## ADDENDUM NO. 1

**PROJECT NAME: NCTA WEST DORM ELECTRICAL & FIRE CODE REMODEL**  
**UNL PROJECT NUMBER: CU07P005**

CONSULTANT: Geary Engineering, Inc.  
ADDRESS: 7800 O Street, Suite 100  
Lincoln, NE 68510

DATE OF ISSUANCE: March 18, 2013  
DATE OF BID OPENING: March 21, 2013

**DRAWING NO. – A1.0 GROUND FLOOR PLAN AND DEMOLITION PLAN**

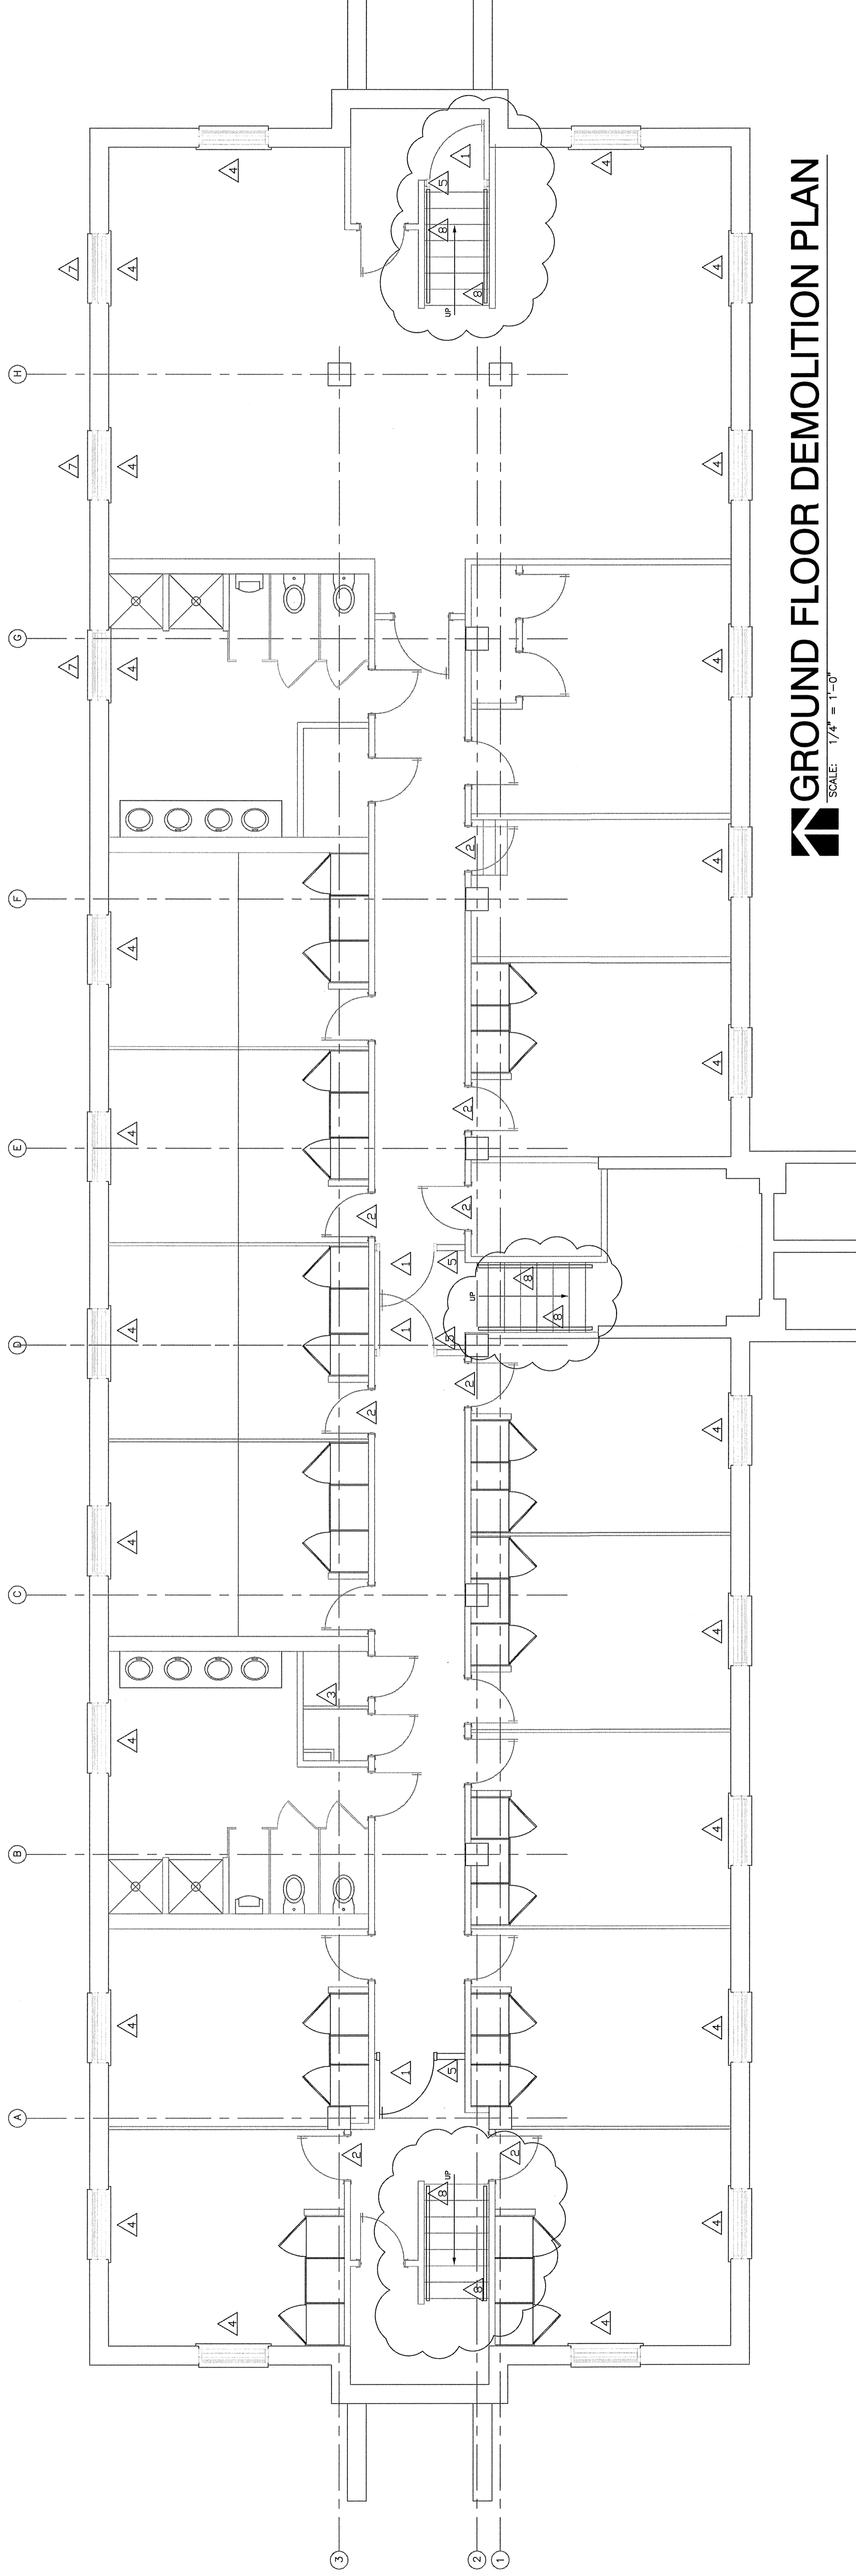
Remove all existing wood hand rails in all three stair towers. Patch and paint plaster as required at locations of removed brackets. Re-install new 1-1/2" diameter pipe railing with a minimum of two brackets for each long run of handrail. Interior handrail will be a continuous run unit, adjust height as required for consistence, 34" above landing and front of nose railing. All railing shall be painted. Refer to the attached drawings A1.0, A2.0 and A3.0.

**GROUND FLOOR PLAN**  
SCALE: 1/4" = 1'-0"

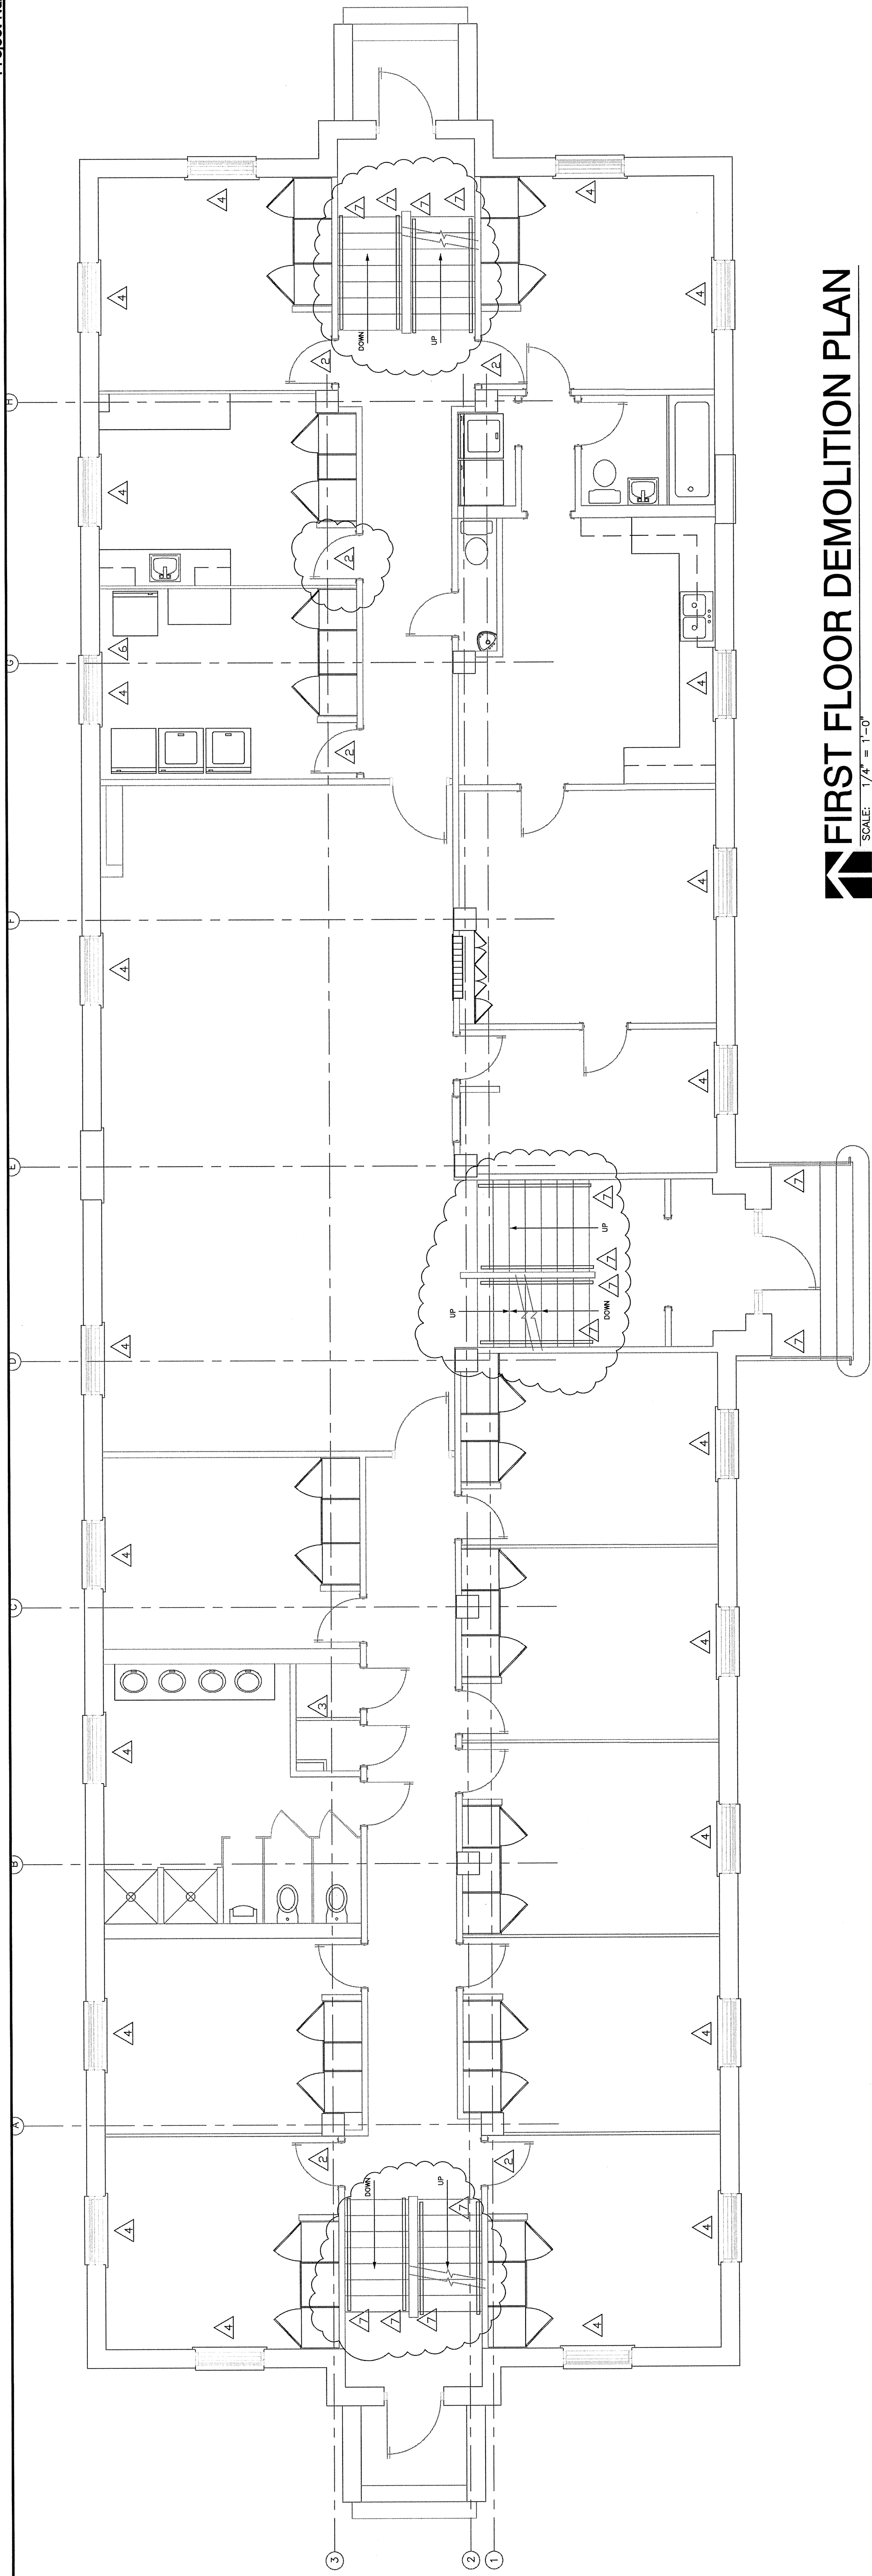
1. Remove all existing wood hand rails in all three stair towers. Patch and paint plaster as required at locations of removed brackets. Re-install new 1-1/2" diameter pipe railing with a minimum of two brackets for each long run of handrail. Interior handrail will be a continuous run unit, adjust height as required for consistence, 34" above landing and front of nose railing. All railing shall be painted. Refer to the attached drawings A1.0, A2.0 and A3.0.

2. Remove existing wrought iron railing at the exterior main entry. Install new single pipe handrail from front edge of the building to 12" beyond the last noise of the exterior tread. Railing will turn down terminate at the sidewalk. Drill a 4" diameter hole in the side walk and compact grout a sleeve for the handrail to fit into and weld. Exterior handrail to be steel and painted. At both of the east and west entry's, install the similar type of handrails as well. Refer to the attached documents.

3. At existing Snack Room 116, remove the existing wood door and replace with a fire rated door and frame, similar to what is being done at Laundry 115.

**FIRST FLOOR DEMOLITION PLAN**  
SCALE: 1/4" = 1'-0"

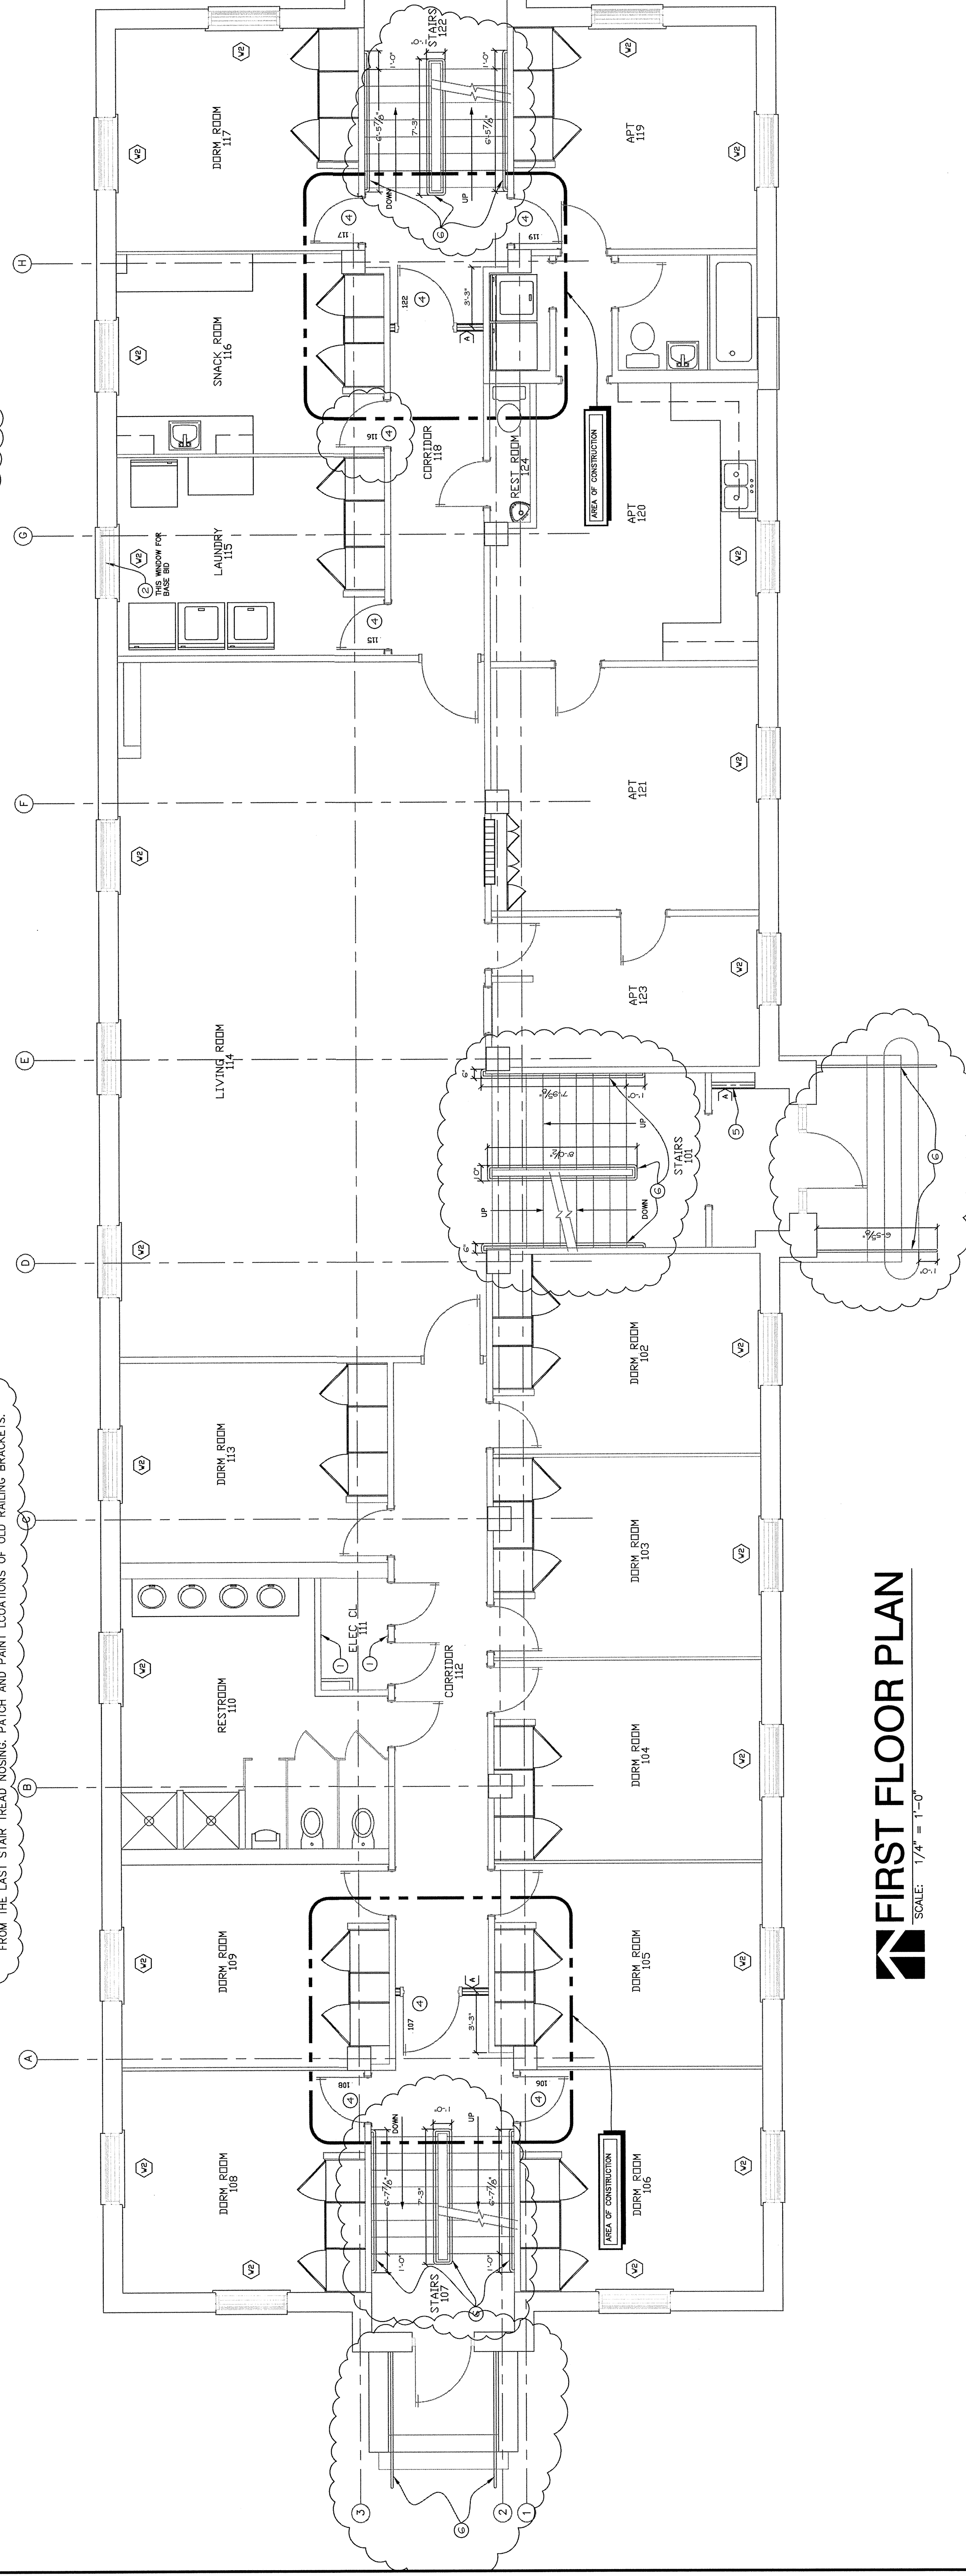
Remove all existing wood hand rails in all three stair towers. Patch and paint plaster as required at locations of removed brackets. Re-install new 1-1/2" diameter pipe railing with a minimum of two brackets for each long run of handrail. Interior handrail will be a continuous run unit, adjust height as required for consistence, 34" above landing and front of nose railing. All railing shall be painted. Refer to the attached drawings A1.0, A2.0 and A3.0.
